<b>Company</b>	Trenz Electronic GmbH
<b>PCN Number</b>	PCN-20210119a
<b>Title</b>	TE0713-02 DDR3 and Flash Change
<b>Subject</b>	BOM change
<b>Issue Date</b>	(2021-01-19), Revised 2021-03-09

## 2.3 #3 Set S/N to not fitted

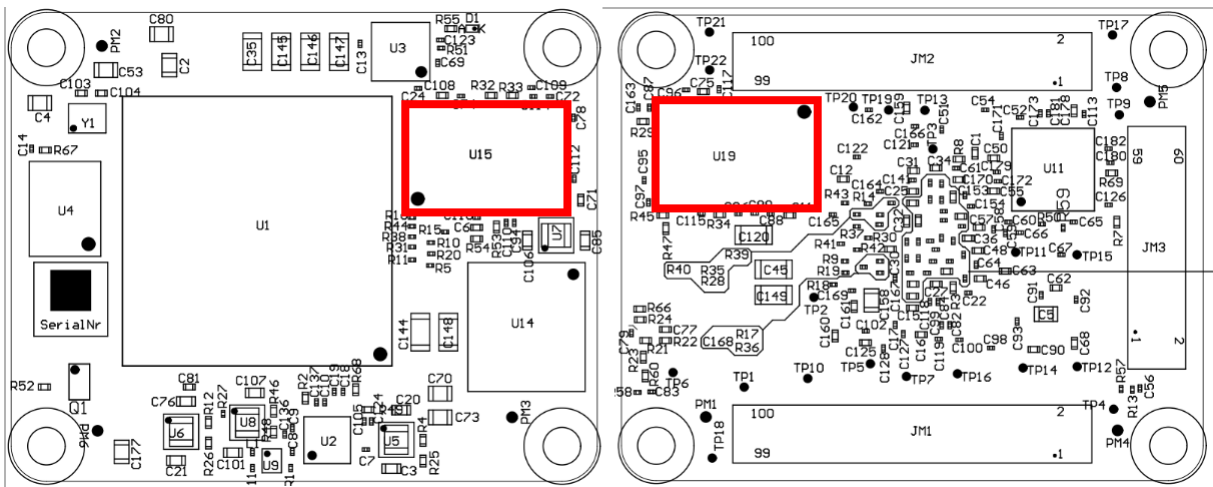
**Type:** BOM change

**Reason:** Part is end of life.

**Impact:** Track it pad no more available.
